ADDENDUM NO. 11

PROJECT TITLE - PA State Police Greensburg - DNA Laboratory Facility New Building

ADDENDUM 11

MEP REVISION #1 - 11/15/2022

DRAWN BY		DATE		DRAWING NO.	
E HOOVER		05/24/2022		E112S	
CHECKED BY		SCALE		(VOLUME 1 OF 1)	
S MULHOLLEN		1/8" = 1'-0"

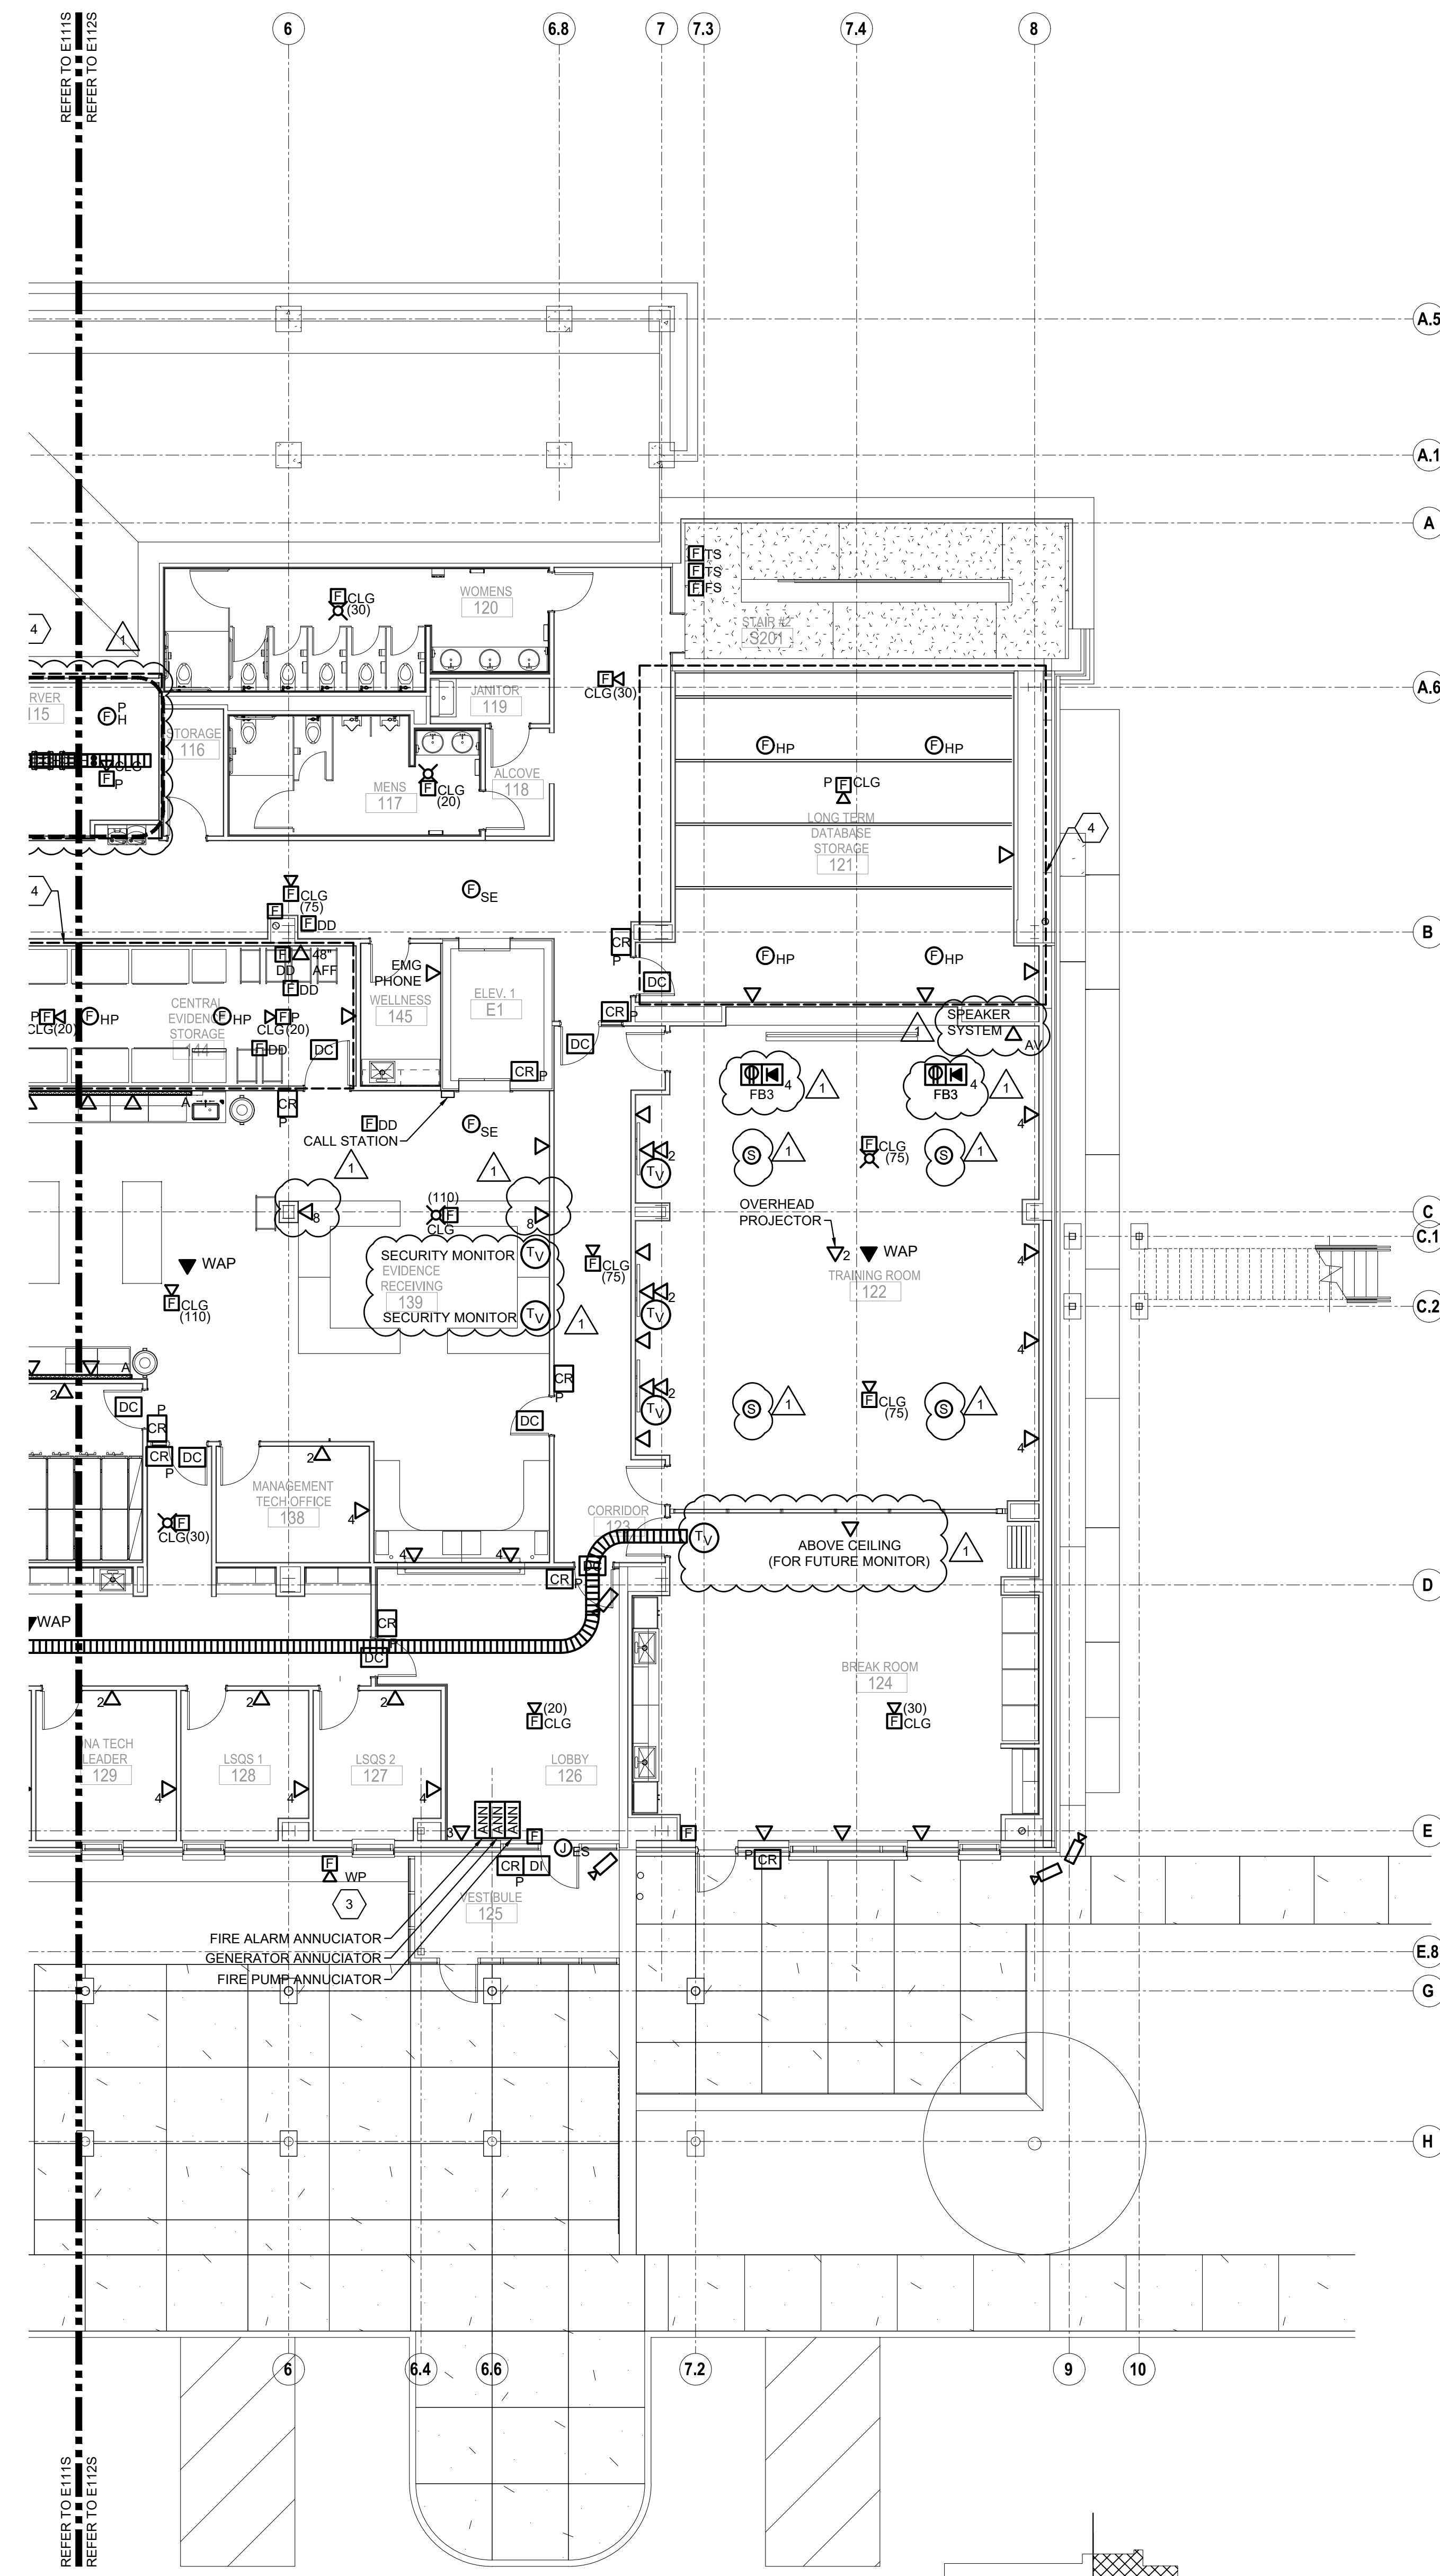
E112S - Added data for (2) security monitors in Room 139.

E112S - Added data for TV monitor above door in room 124.

E112S - Added data for future monitor (above ceiling) in room 124.

E112S - Added (1) AV box for speaker system and pathways for (4) ceiling speakers to AV box, room 122.

E112S - Added (2) Floor boxes in room 122.

DRAWN BY E HOOVER	DATE 05/24/2022	DRAWING NO. E113P (VOLUME 1 OF 1)
CHECKED BY S MULHOLLEN	SCALE 1/8" = 1'-0"

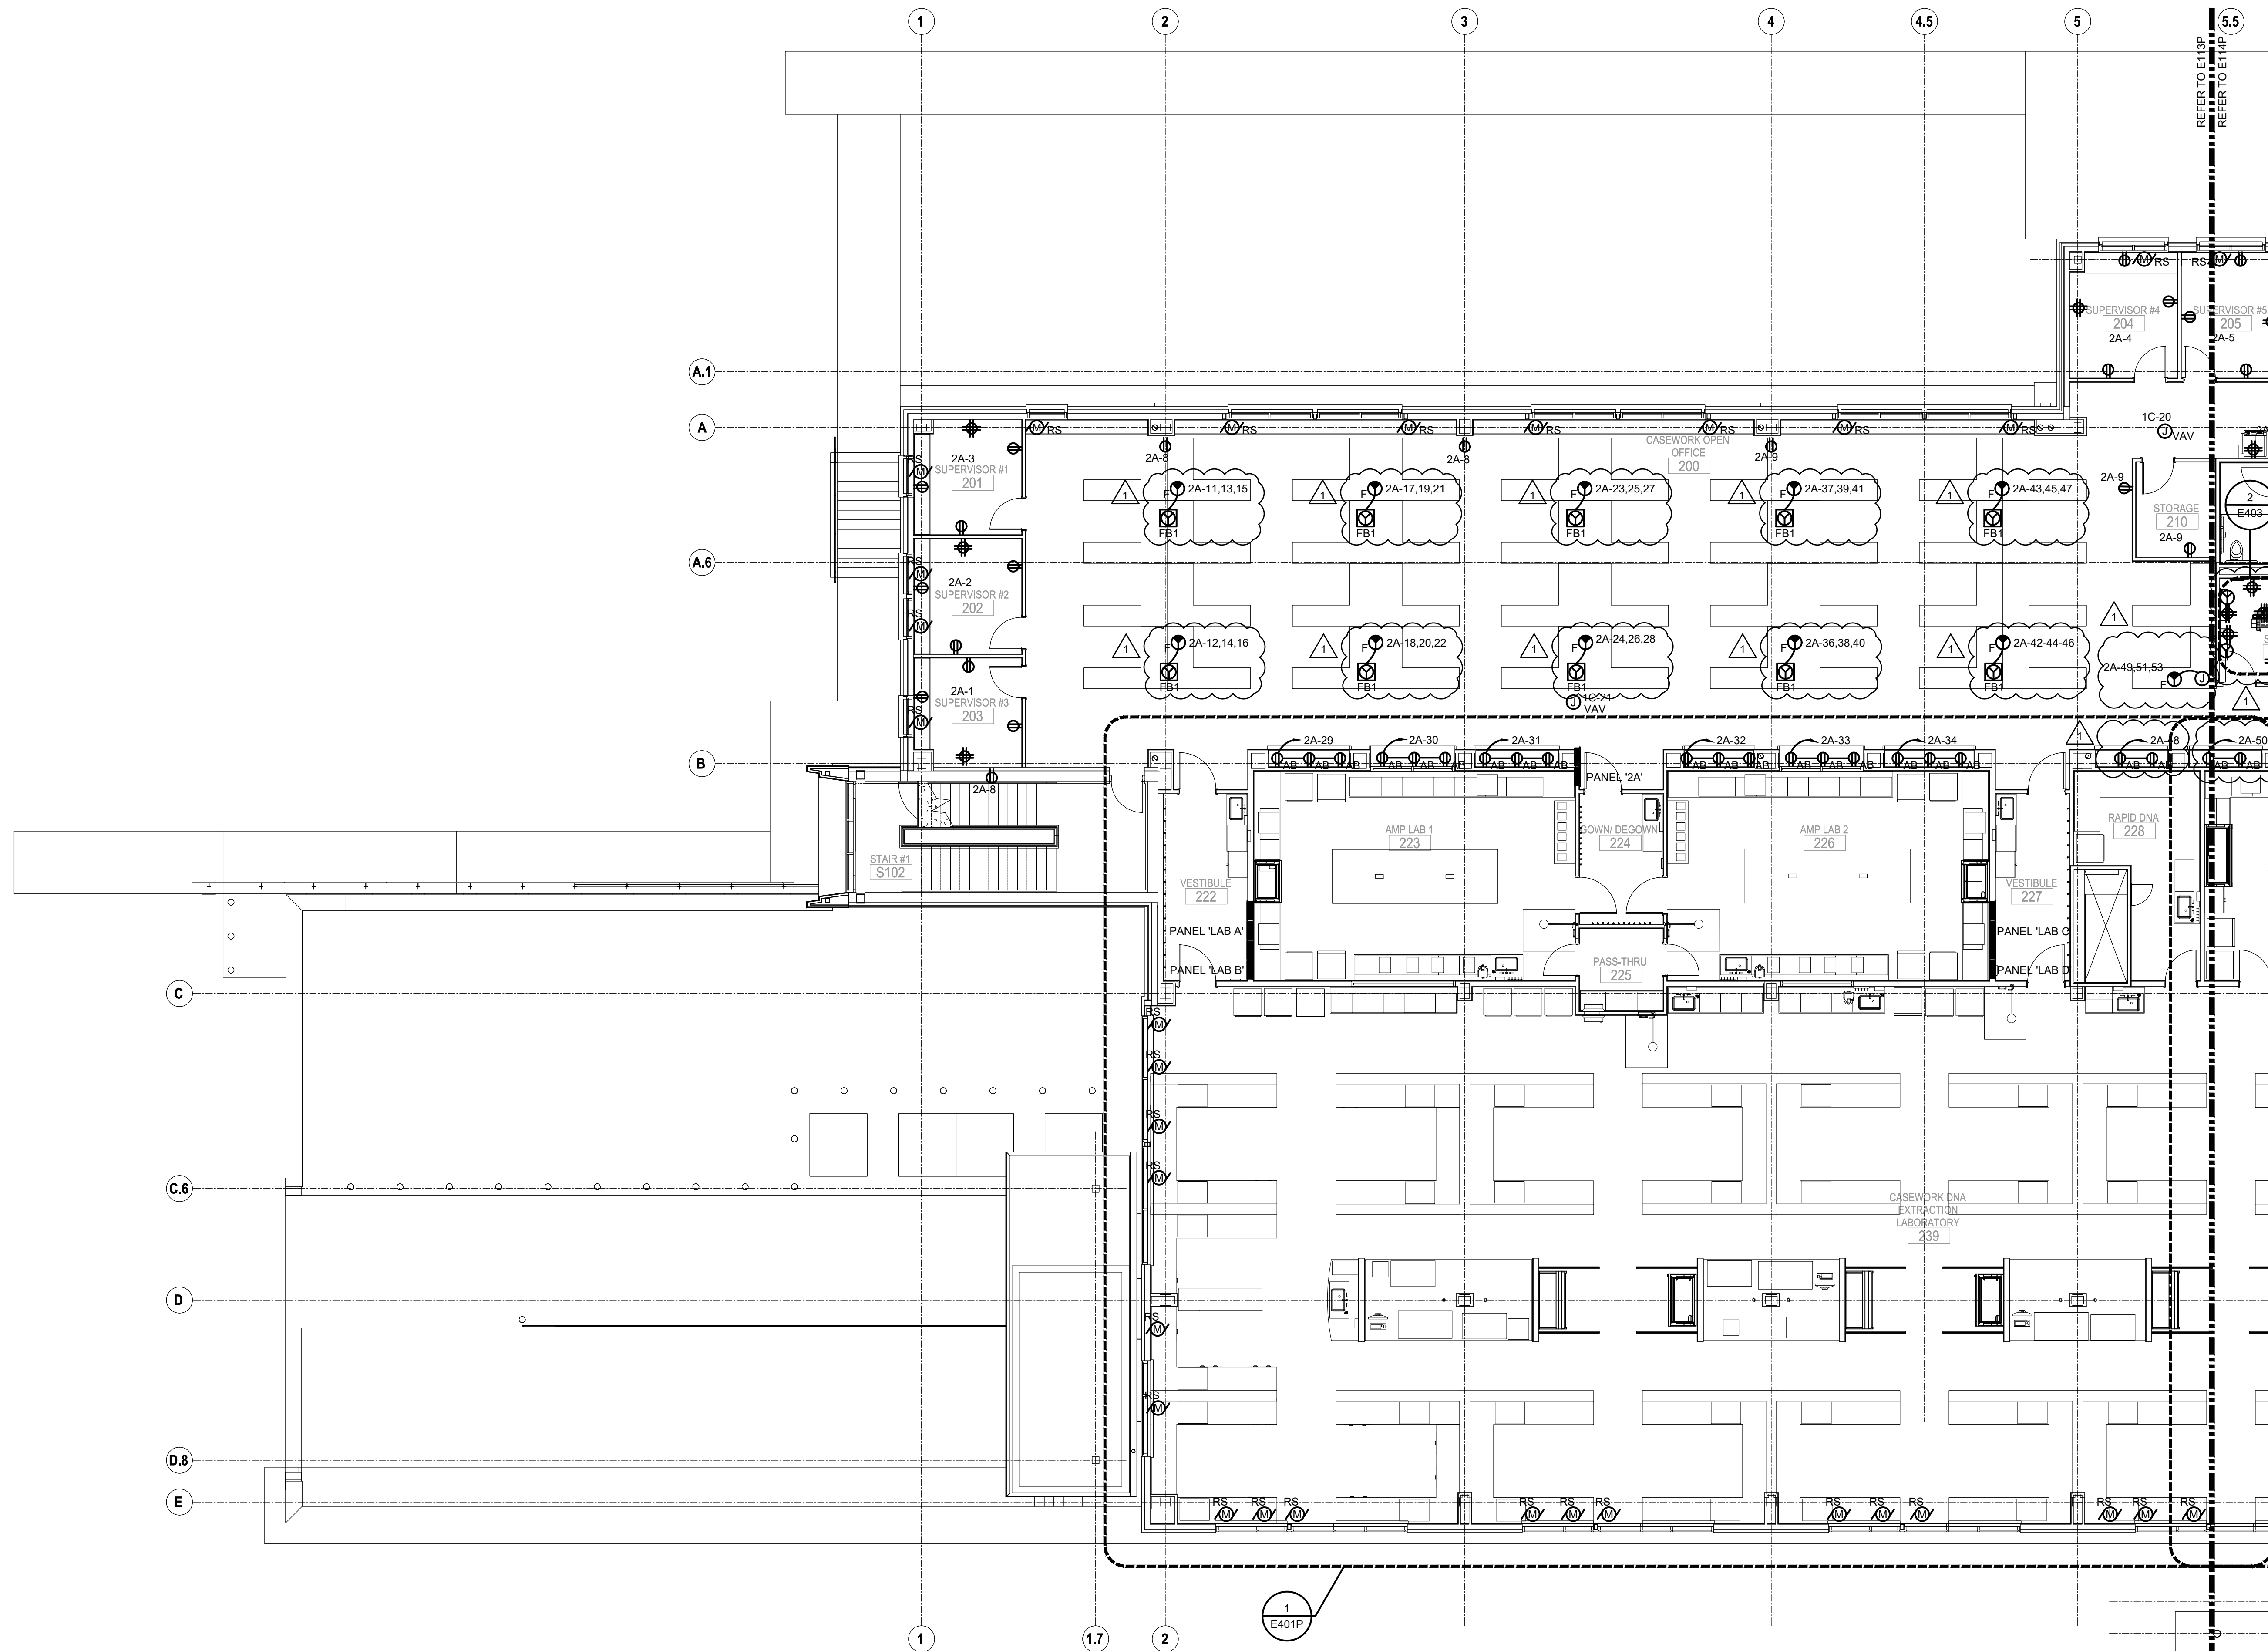
E113P - Updated symbol and added identification tag for Furniture feeds in room 200.

E113P - Updated symbol and added identification tag for wall-fed furniture feed in room 200.

E113P - Updated symbol and added identification tag for wall-fed furniture feed in room 200.

E113P/E114P - Added (6) receptacles, assigned previous receptacles "above counter" in corridor 216. Assigned to panel "2A" circuits 48, 50, 52.

FLOOR PLAN - UPPER LEVEL - PARTIAL PLAN 'A' SYSTEMS	
DRAWN BY E HOOVER	DATE 05/24/2022
CHECKED BY S MULHOLLEN	SCALE 1/8" = 1'-0"
E113S (VOLUME 1 OF 1)

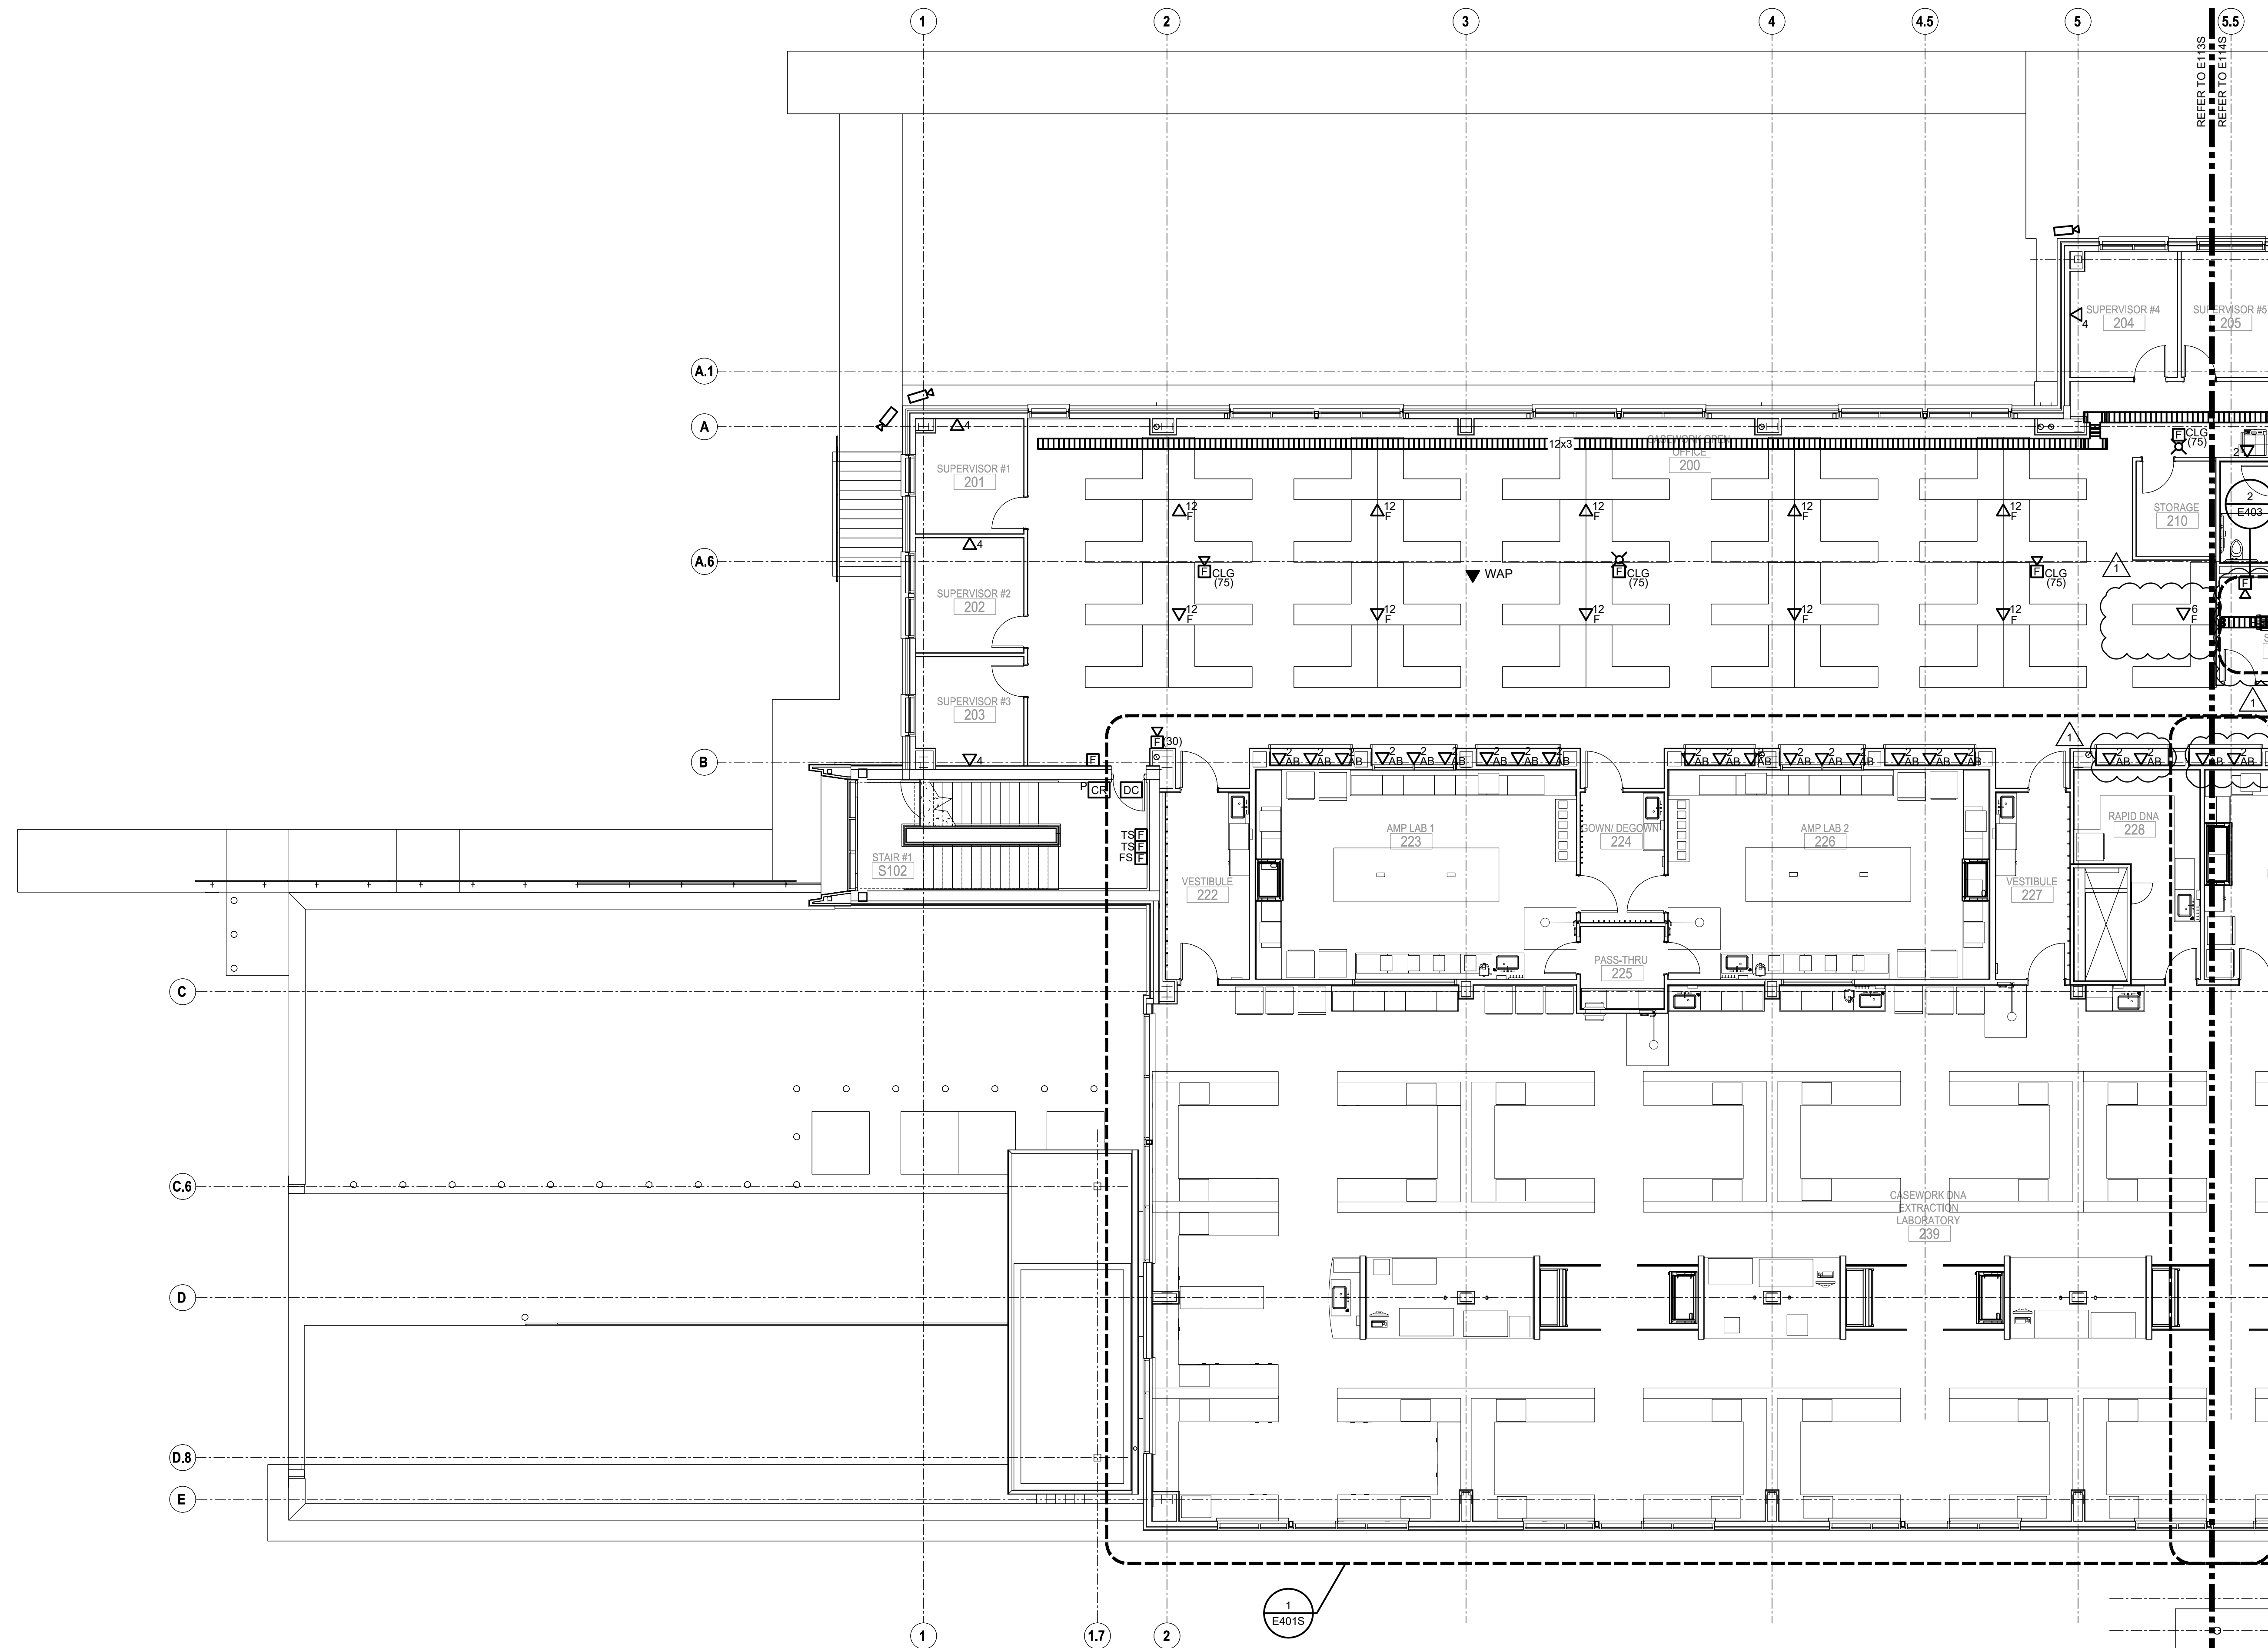
E113S - Added furniture feed with 6 data drops in room 200.

E113S/E114S - Added (12) data outlets, assigned previous outlets "above counter" in corridor 216.
